TOWN OF CORTLANDT PLANNING BOARD

**MEETING AGENDA..... PLANNING BOARD
TOWN OF CORTLANDT
6:30 TUESDAY EVENING*
MARCH 3, 2026**

PB 2025-7 a. Public Hearing: Application of the Yeshiva Ohr Hameir for Site Plan approval, an amended Special Permit for a University, College or Seminary and a Wetland Permit for a proposed 51,730 sq. ft. dormitory building, the repurposing of other buildings on site, and site improvements including stormwater, landscaping and building façade renovations located at the existing Yeshiva Ohr Hameir campus at 141 Furnace Woods Rd. Drawings latest revised February 18, 2026. (see prior PB 7-09)

LaBella has performed a review of the plans prepared by Ciarcia Engineering, P.C. in support of the “Amended Site Plan associated with the construction of the three-story dormitory building, extension of sanctuary building, conversion of existing classrooms to staff housing, storage building, cafeteria and kitchen renovations, chalet renovation, façade improvements, and associated utility improvements. submitted on February 9, 2026.

DORMITORY CHALET ADA ACCESS
SCALE: 1"=20'

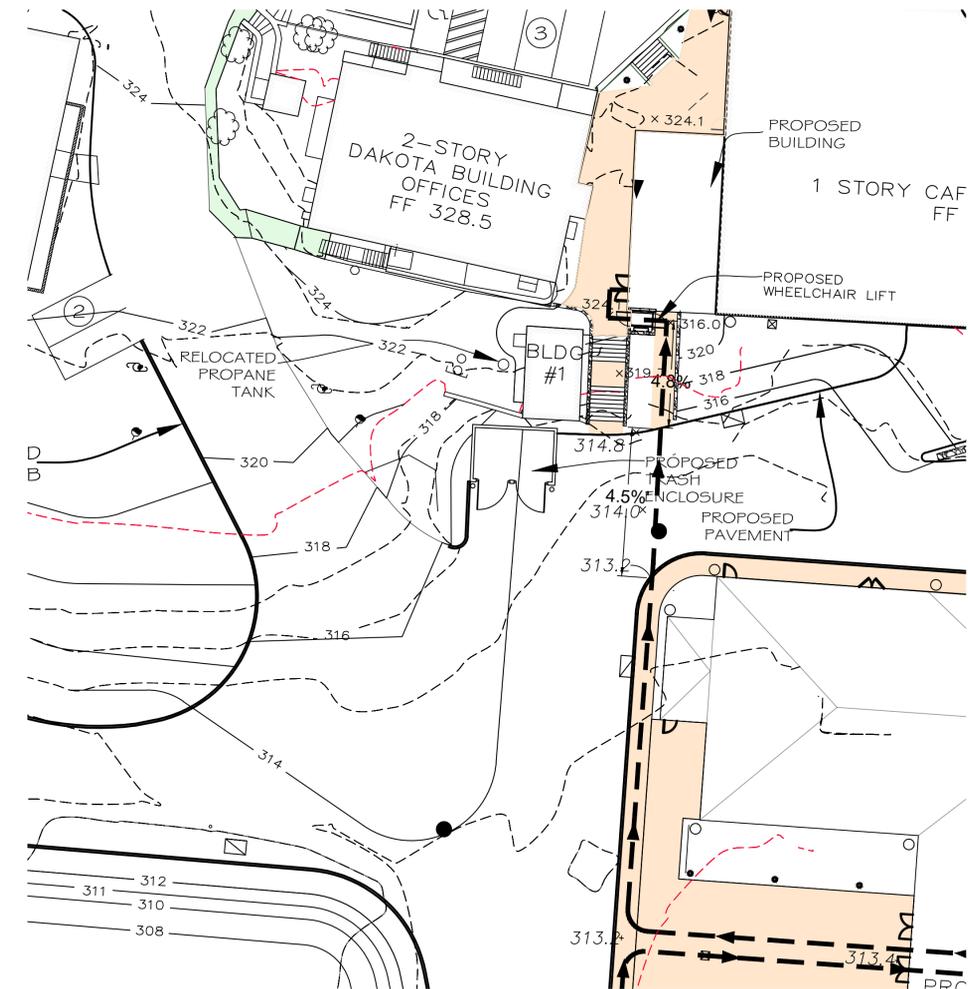
1. **Sheet 1 of 15 – Accessible routes from the dorms and living quarters to cafeteria shall be depicted and adequate slope conformance provided. This will require depicting proposed grading and spot elevations, to confirm slope. A slope of 5.3 % is shown which exceeds maximum allowable slope of 5% for an ADA path. PREVIOUS COMMENT NOT ADDRESSED.**

2. **Sheet 1 of 15 – Adequate slopes for ADA accessible spaces shall be demonstrated as well as accessible routes to building entries from said spaces. This will require additional contours and spot elevations at the end and beginning of each parking space to demonstrate compliance with maximum allowable ADA parking slope of 2%. PREVIOUS COMMENT PARTIALLY ADDRESSED.**

SHEET NUMBER
416

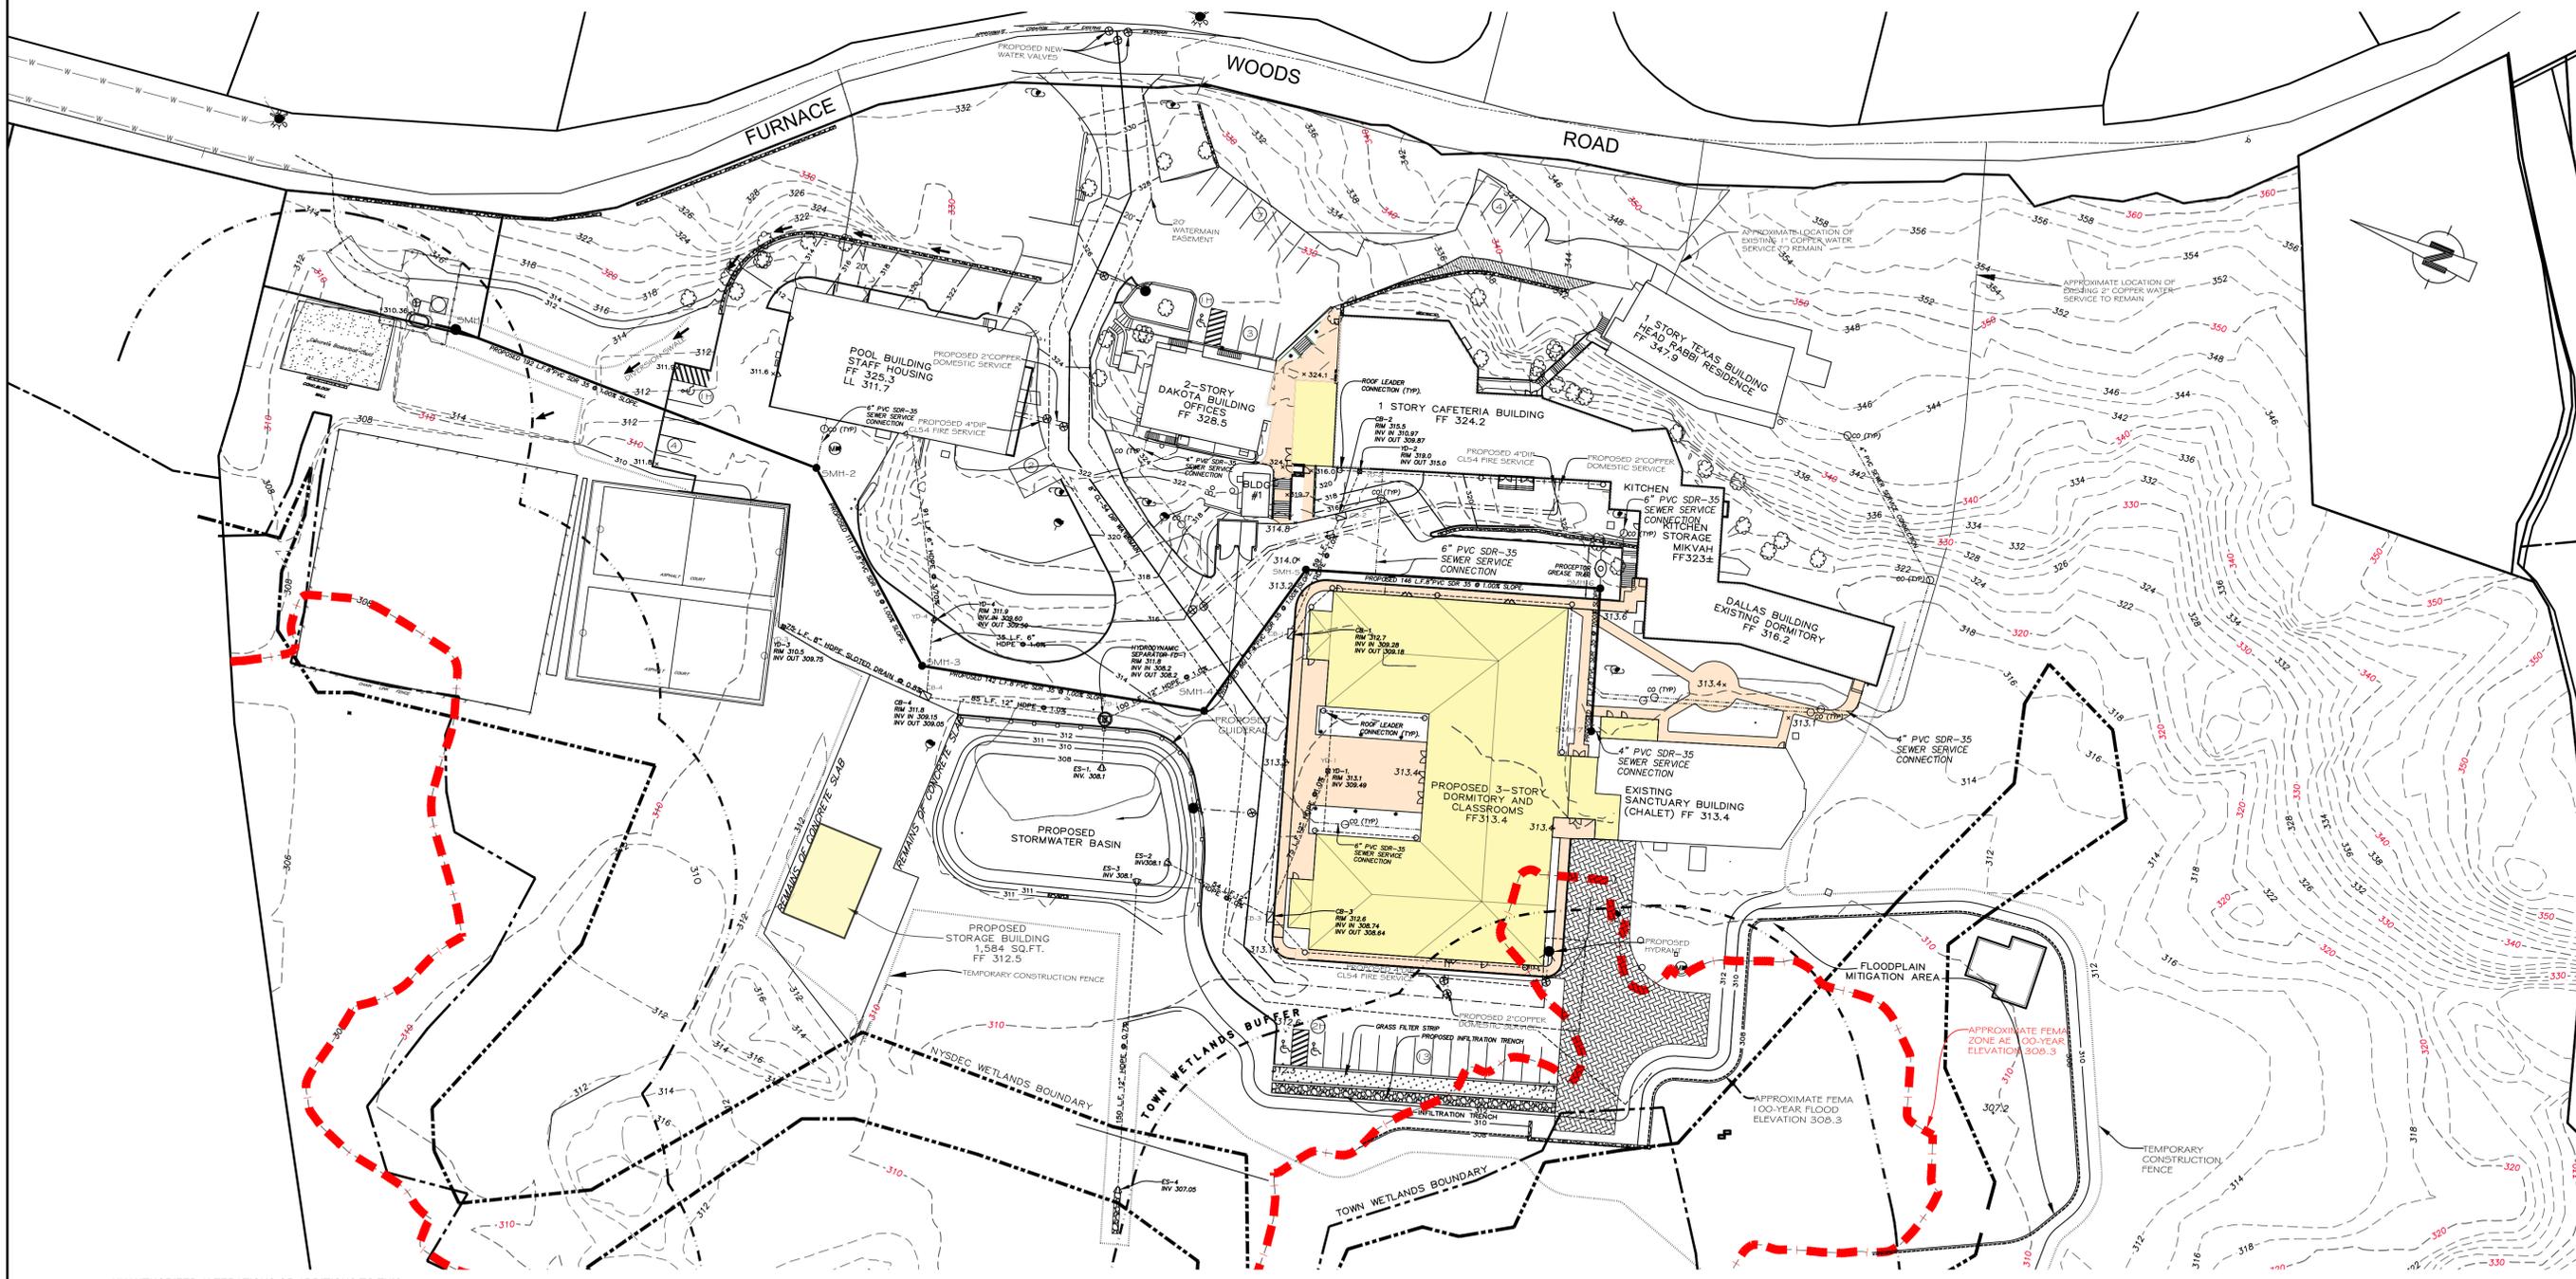
12. Sheet 4 of 15 - Maximum fire access drive slope is 10%. Grading revisions will need to be made to accommodate the slope. **PREVIOUS COMMENT PARTIALLY ADDRESSED.**

13. Sheet 4 of 15 - Depict how roof leaders will be connected to the on-site drainage system for all improvements and provide pipe sizes and slopes for all improvements. **PREVIOUS COMMENT PARTIALLY ADDRESSED**

14. Sheet 4 of 15 - Depict how the proposed stormwater basin will discharge. **PREVIOUS COMMENT PARTIALLY ADDRESSED.**
15. **Sheet 4 of 15** - Proposed grading is depicted within the NYSDEC wetland for the fire truck turn around and floodplain mitigation. Please provide correspondence from the NYSDEC approving this.

16. Sheet 4 of 15 - Provide contours and spot elevations for new sidewalks between Dallas Building and Chalet Building, surrounding the new dormitory, and courtyard; spot elevations on the west side of dormitory; contours on east side of dormitory; and spot elevations between the proposed dormitory and staff building to decipher flow of runoff. **PREVIOUS COMMENT PARTIALLY ADDRESSED.**

17. Sheet 4 of 15 - Provide top and bottom elevations for all walls. **PREVIOUS COMMENT NOT ADDRESSED**
18. Sheet 4 of 15 - Label all watermain tees, hydrants, and valves. **PREVIOUS COMMENT NOT ADDRESSED**

19. **Sheet 4 of 15** - Label all rim and invert elevation of drainage structures.
20. **Sheet 4 of 15** - Show the analyzed floodplain elevation.
21. Sheet 5 of 15 - The sequencing notes indicate the construction of a sediment trap during the course of construction, which appears to be at location of stormwater management basin. Plan should identify outlet of trap and provide calculations for sizing the depth and area of disturbance being captured. Also provide details of sediment trap. **PREVIOUS COMMENT PARTIALLY ADDRESSED.**

**PROPOSED ON-SITE
 STORM DESIGN**

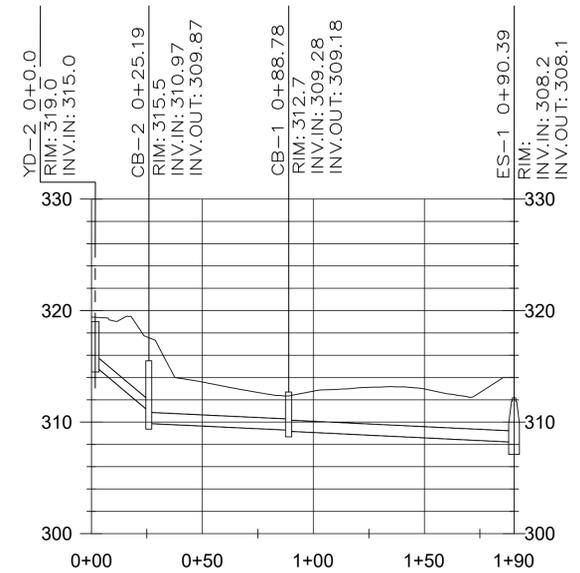
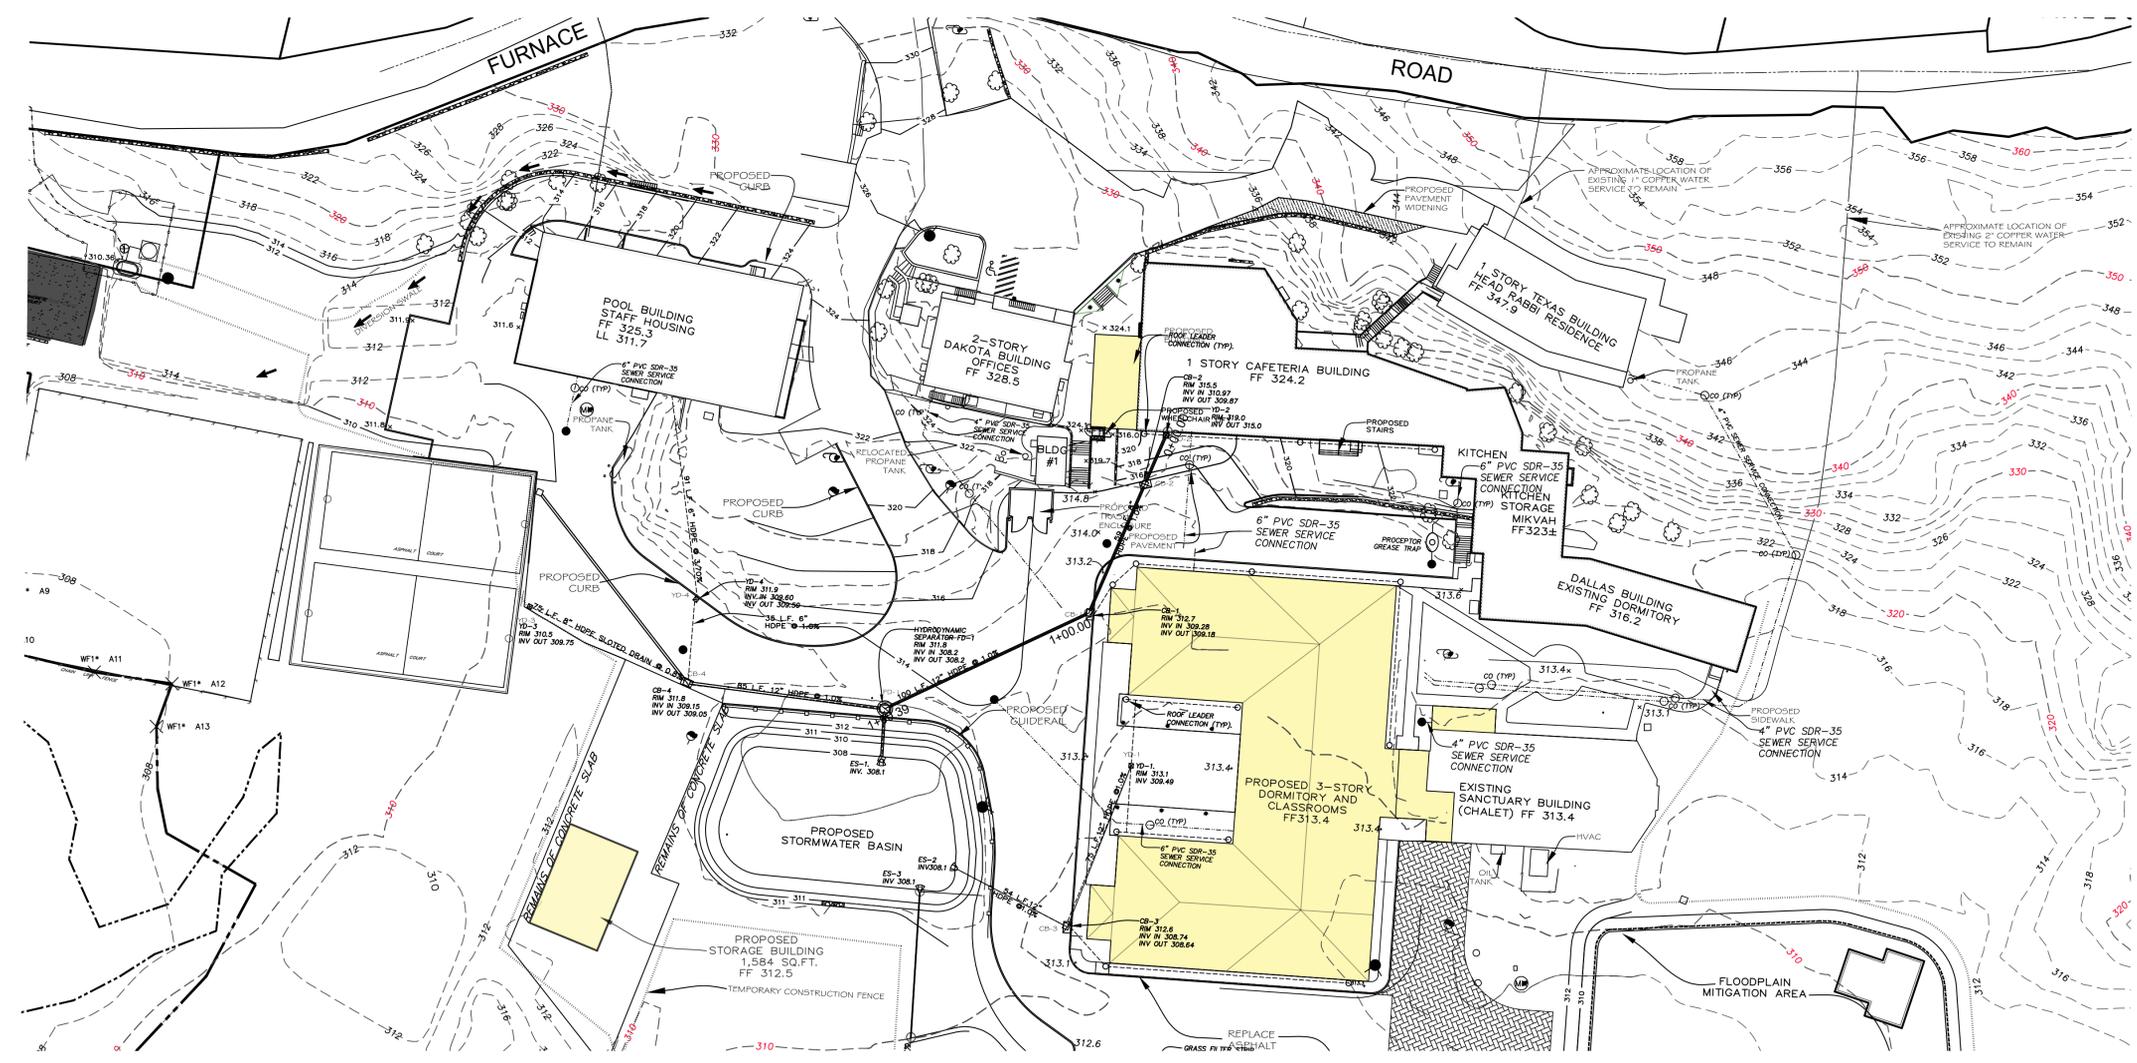
Comment 19: Sheet 4 of 15 – Label all rim and invert elevations of drainage structures.

Response 19: The revised plans include rim and invert elevations on the Proposed On-Site Storm Design plan (Sheet 7 of 16).
